Project Name: Village At Mill Pond - Master Plan Design Criteria Amendments

Project Description: Amendments to the Design Criteria for the Village At Mill Pond - Master Plan.
See attachment for proposed amendments.

The Village At Mill Pond Design Guidelines - Explanations

TOWNHOME WITH SAME FLOOR PLAN IN EACH BUILDING

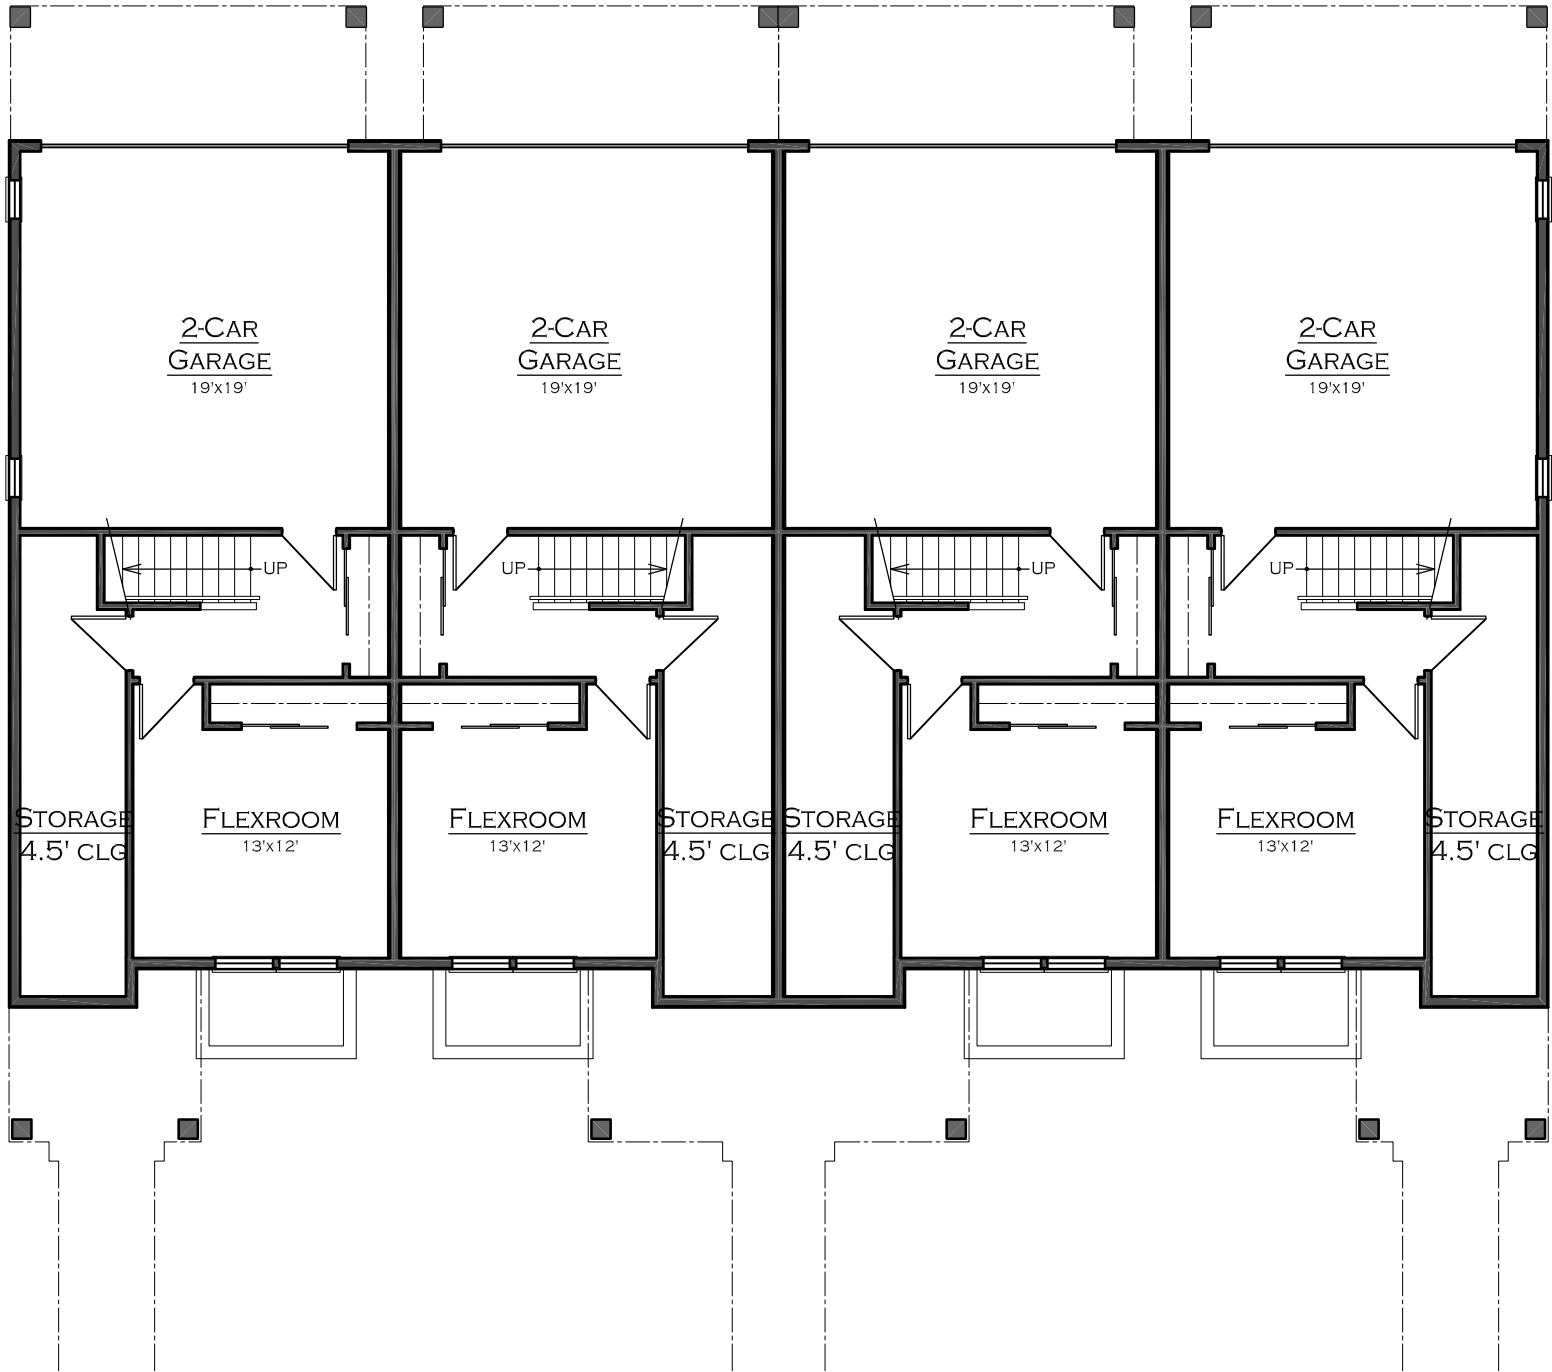
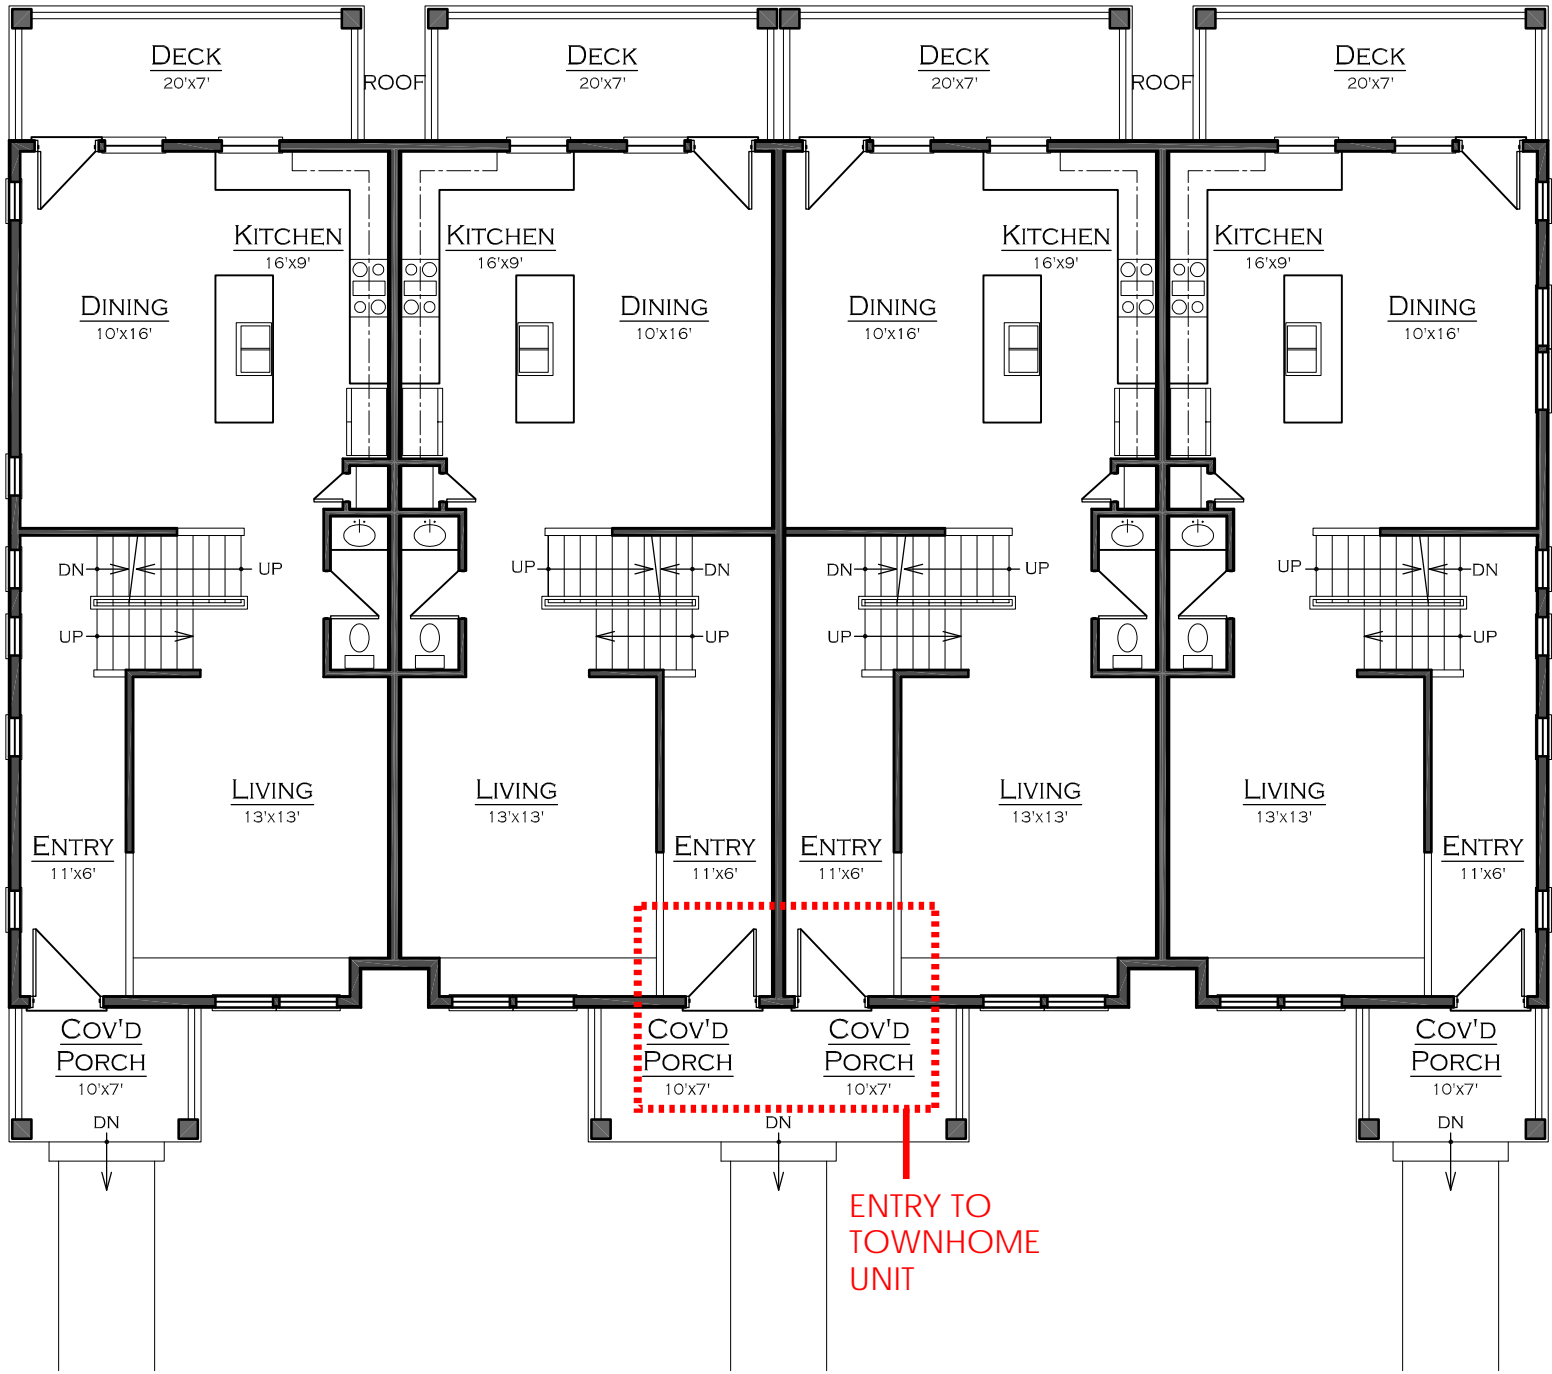
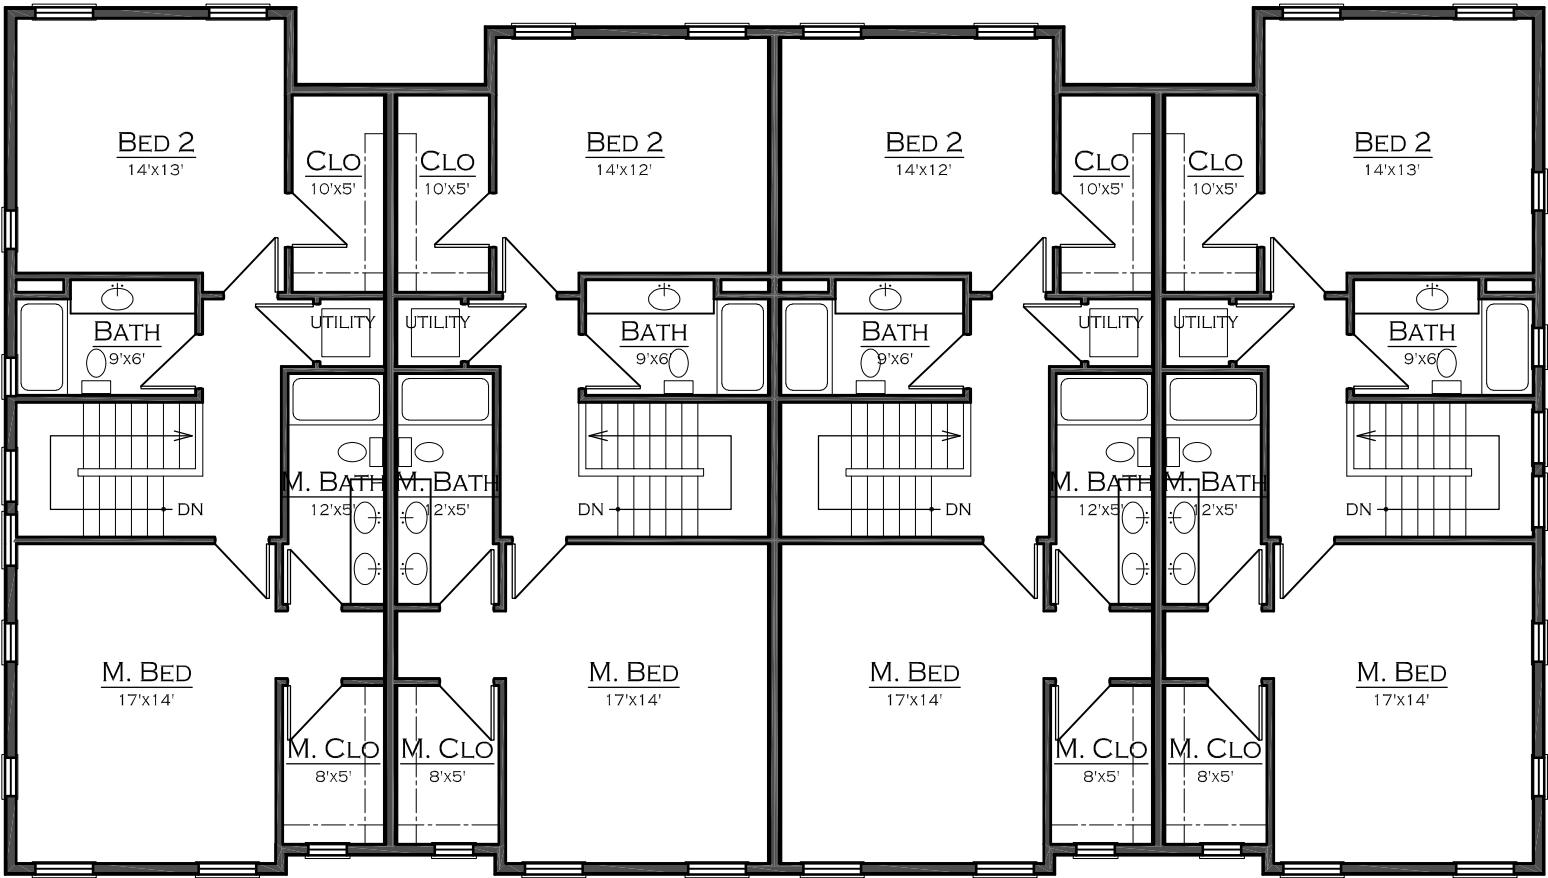
Homes should have significant variations in the floor plans, which allows for variety in the massing of the home, with the exception that townhomes may have the same floorplan within each building.

This is a clarifying addition to the design criteria. Currently duplex, triplex & quadruplex style townhomes are part of the master plan development. Each unit within the townhome buildings will be repeated which allows for consistency in exterior appearance, economy in construction, and clarity in design. The goal of providing variety in buildings & units is maintained through compliance with other design guidelines for this development.

See attachment 1-A, 1-B and 1-C for floorplan examples of townhomes with similar floorplans.

EXISTING DESIGN CRITERIA

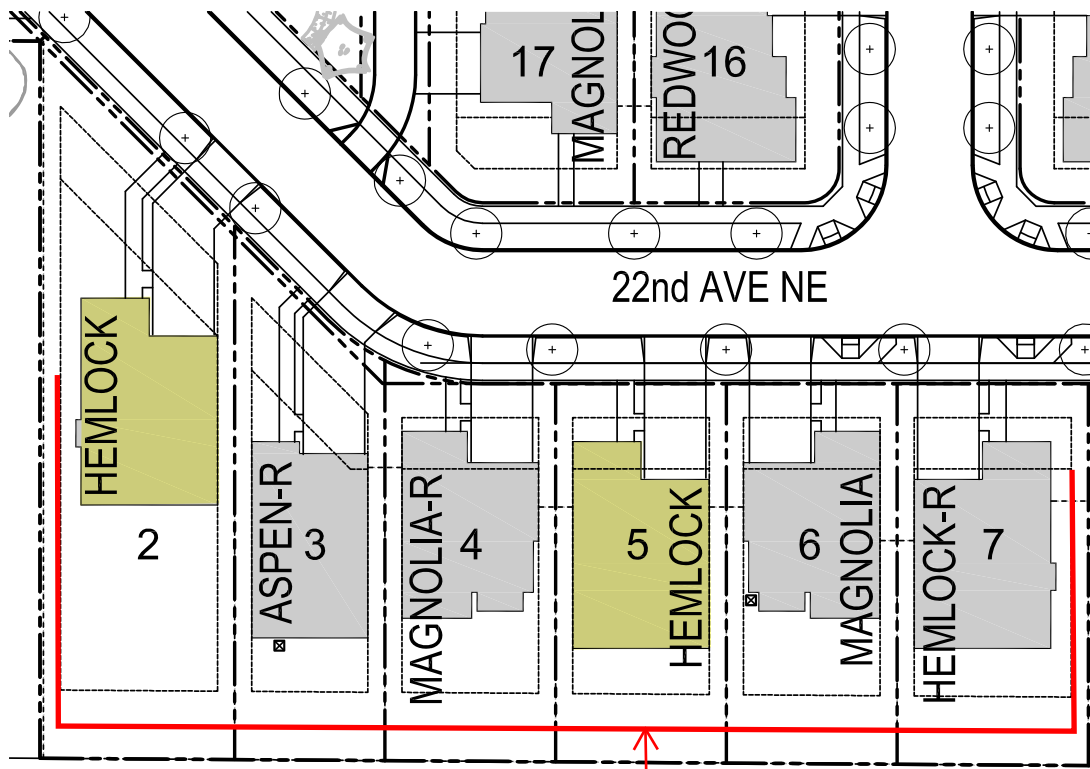
- No more than two of the same model and elevation will be built within six continuous lots. ~~within eight contiguous lots.~~

There are currently 12 different single-family model options to choose from at the Village at Mill Pond. The current 2 per 8 contiguous lot requirements does not provide for flexibility in market demand. Inevitably there are certain models that are more popular among prospective home buyers. Revising the contiguous requirement from 8 to 6 would create more options for development and accommodate pre-selling lots with a desired model type that is contrary to the original layout.

See attachment 2-A site plan example of one model configured in a 2 per 8 contiguous lot layout and another model in 2 per 6 contiguous configurations.
